**La Jolla Shores Planned District Advisory Board (LJSPDAB)
APPLICANT PROJECT INFORMATION FORM**

- Project description: _____New two-story SFD, 5284 sf plus 912 sf garage, pool and site stabilization_____
- Please indicate the action you are seeking from the Advisory Board:

RE: **Site Development Plans**
Cycle Issues –**Responses**
Project Number: **PRJ-1104699**

Subject: PRJ-1104699 Livewire, La Jolla Scenic Dr- 2nd Assessment Letter
Internal Order No. 24009702; La Jolla Community Plan Area

Consistent Setback

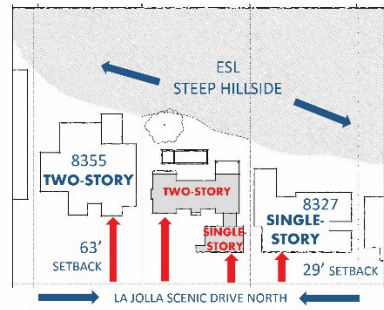
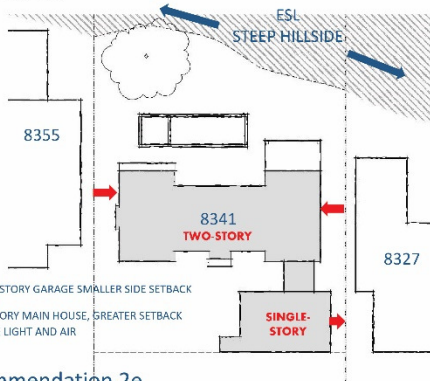
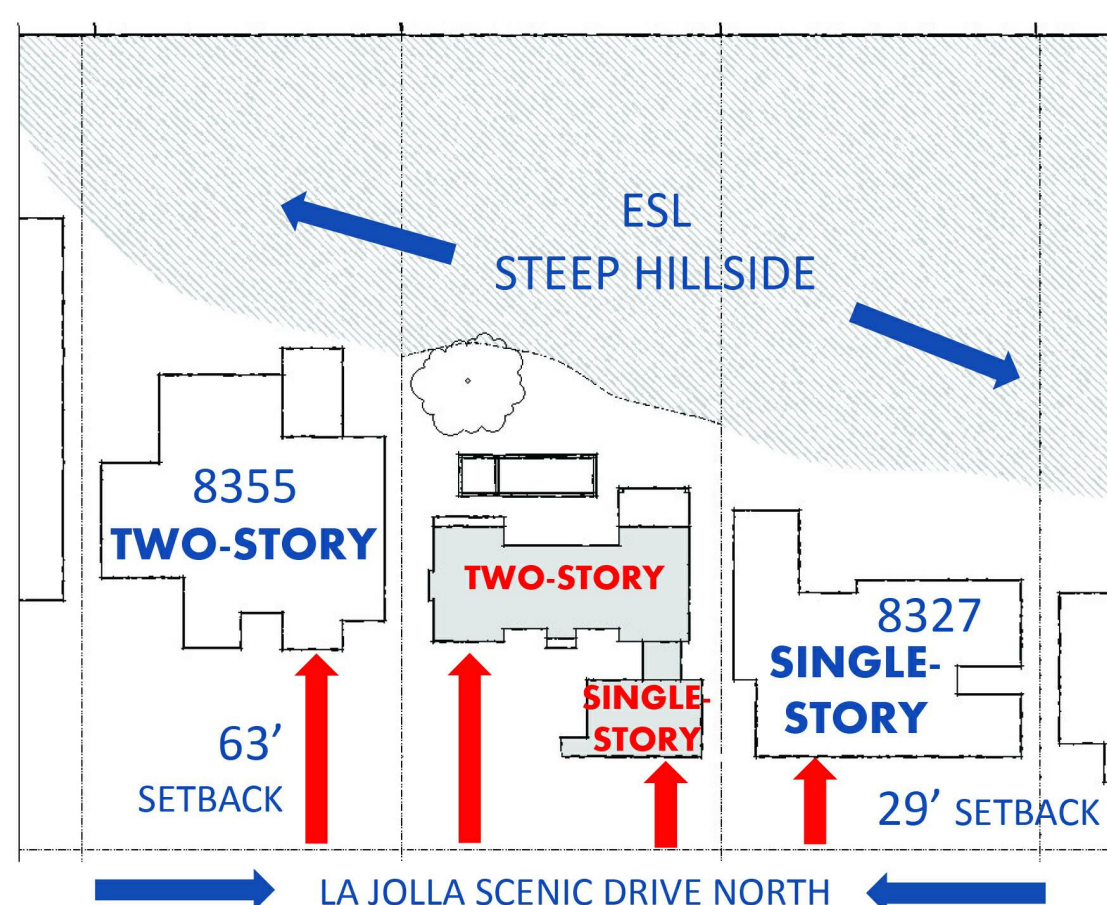
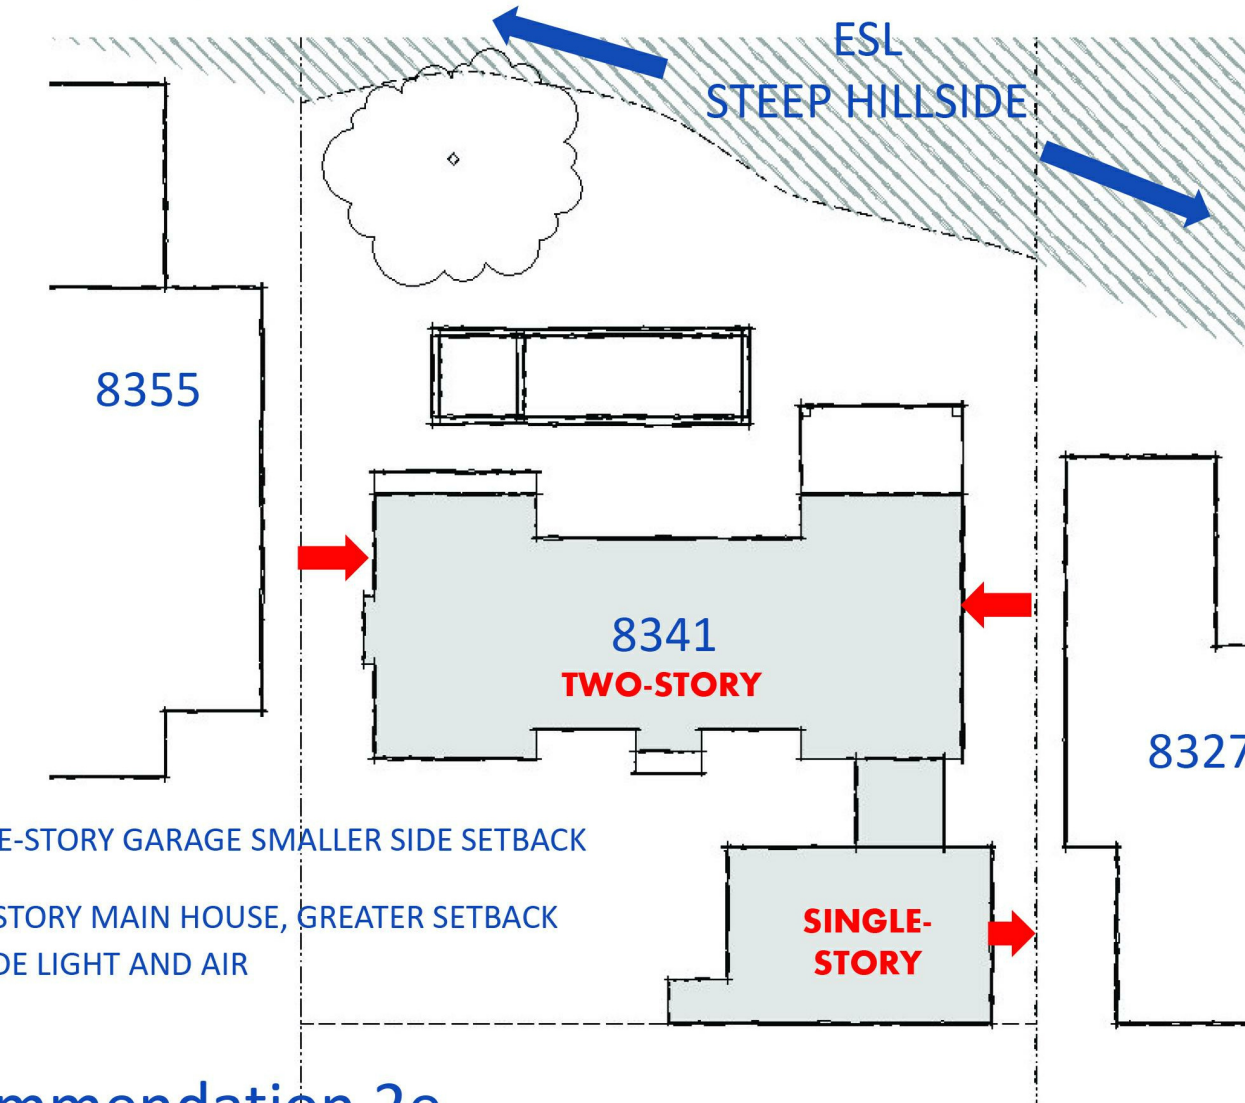
8. Per Building & Zoning Plat Map 252-1695, there is a 29' established front setback. Please label this as "established setback" on the site plan.
9. On the neighborhood survey, please add the side yard setbacks to: 8332, 8322, 8312, 8302, and 8298 Sugarman Drive.

Neighborhood development proceeded from the North and from the South independently, creating two inconsistent setbacks converging at this site.

Recommendation 2e

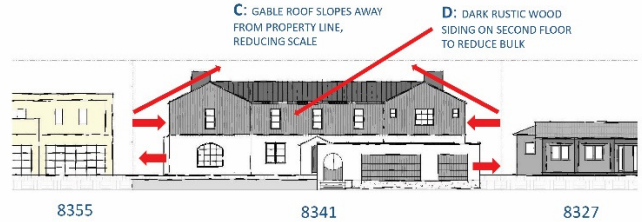
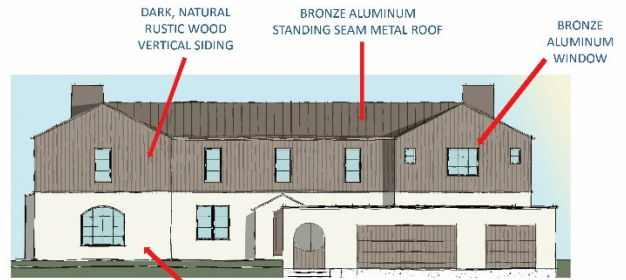
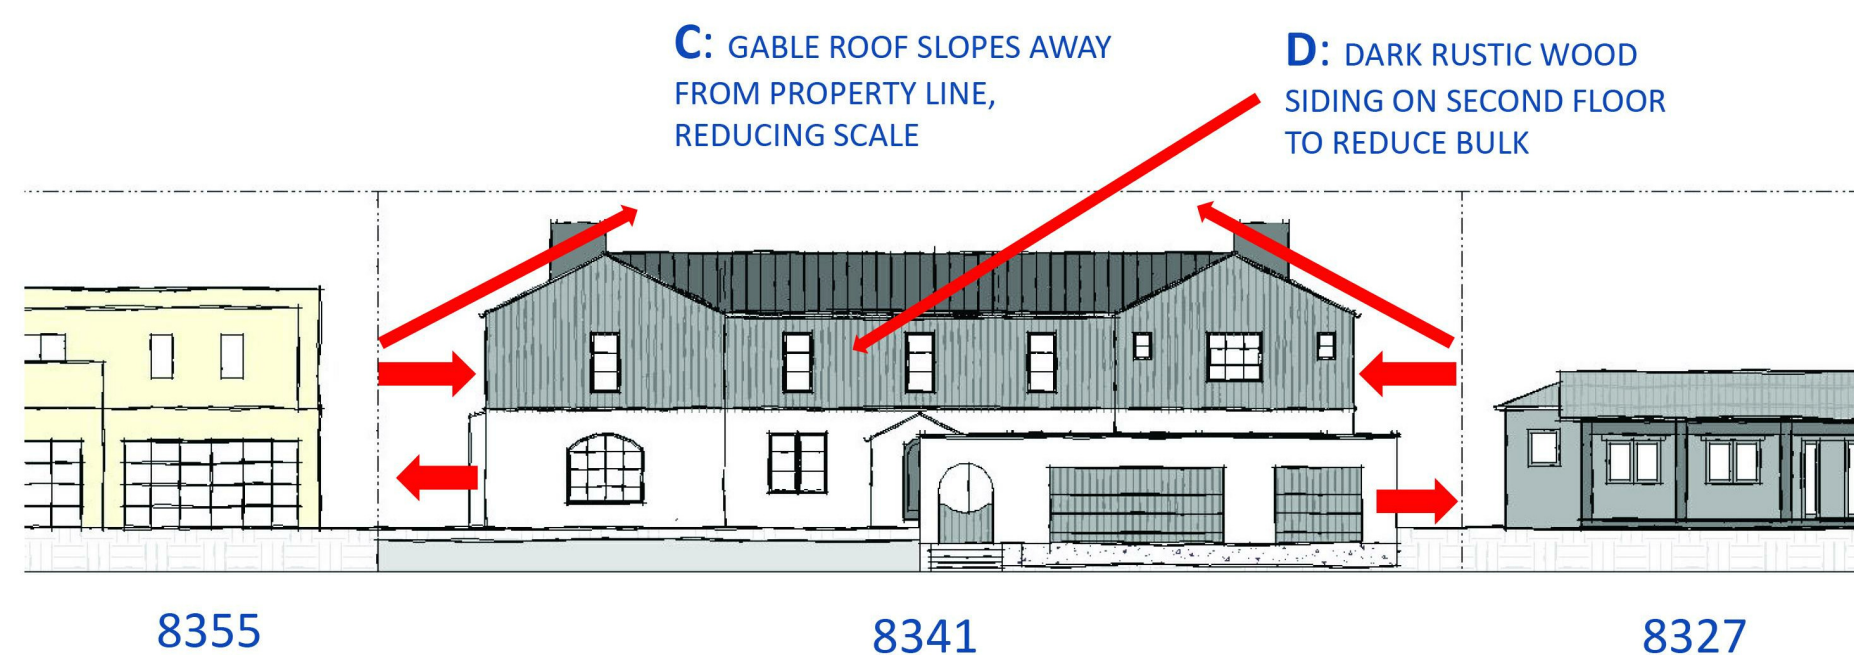
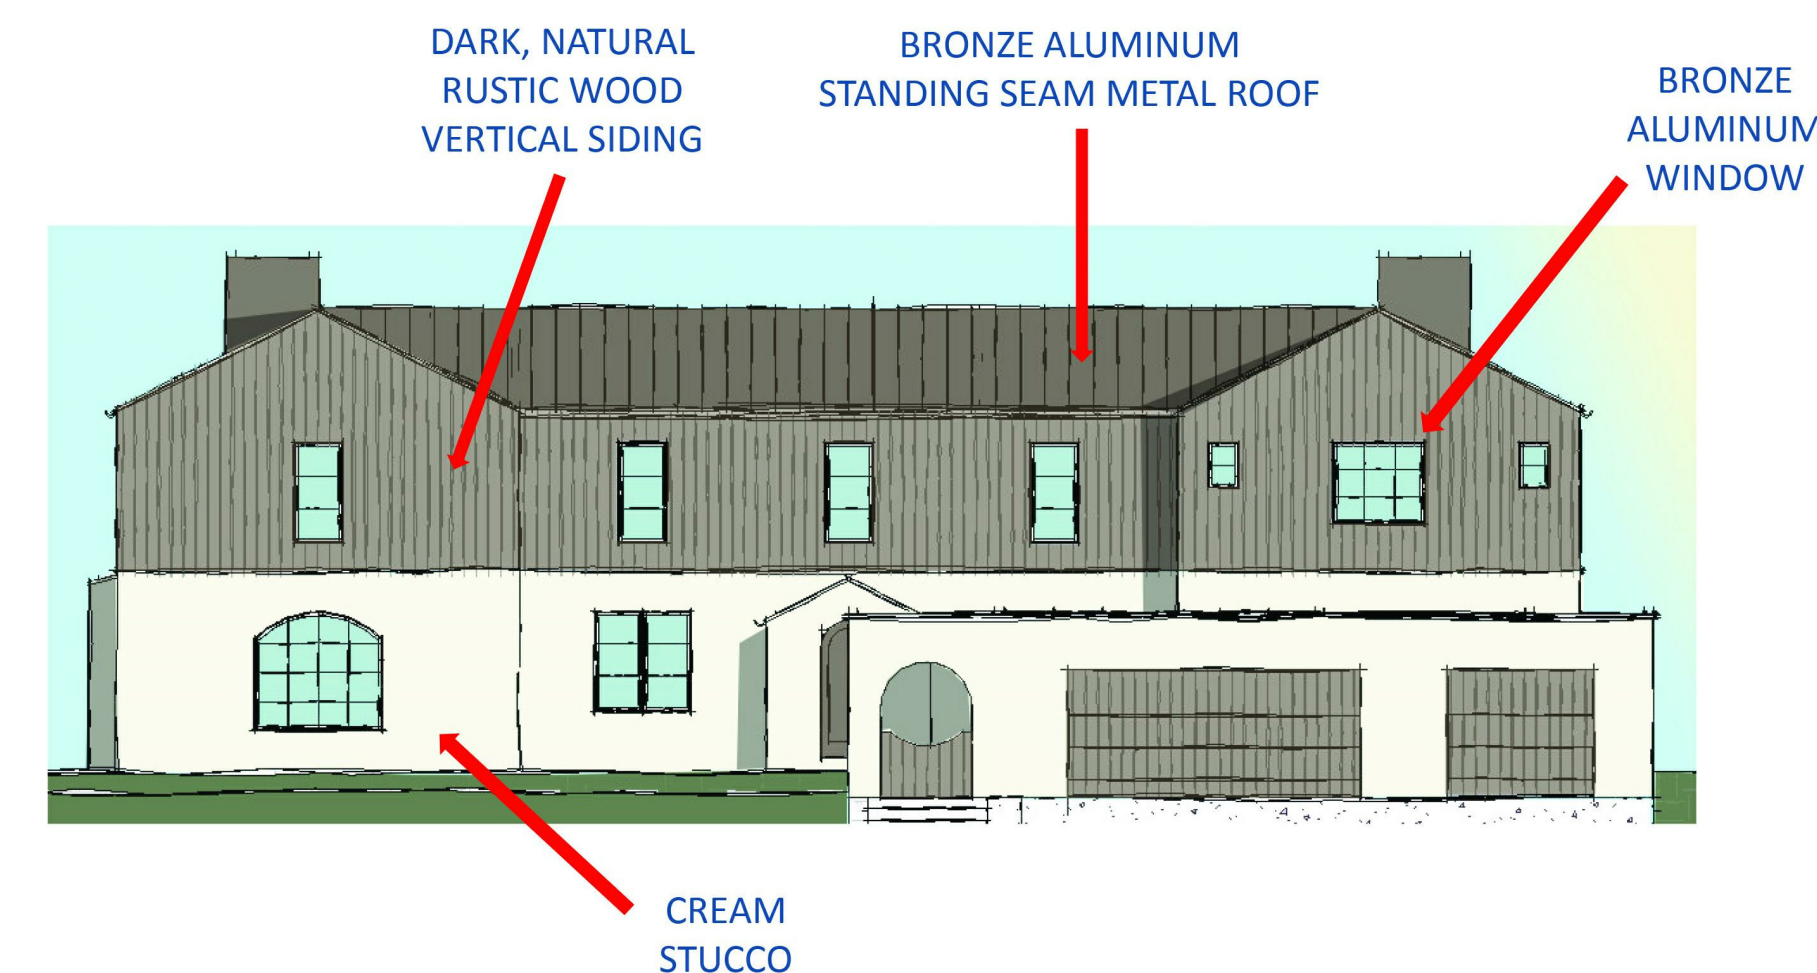
23. **Recommendation 2e.** In order to address transitions between the bulk and scale of new and older development in residential areas, maintain the existing 30-foot height limit of the single dwelling unit zones and Proposition D. Structures with front and side yard facades that exceed one story should slope or step back additional stories, up to the 30-foot height limit, in order to allow flexibility while maintaining the integrity of the streetscape and providing adequate amounts of light and air. Please provide a response addressing how the proposal steps back at the additional stories.

- f. (22) No response required
 - g. (23) Recommendation 2e:
 - i. PowerPoint Presentation provided to Community Plan Area Board (see following page for pdf version). Also provided within set on A9

A: SINGLE-STORY SMALLER SIDE SETBACK

B: TWO-STORY MAIN HOUSE, GREATER SETBACK TO PROVIDE LIGHT AND AIR
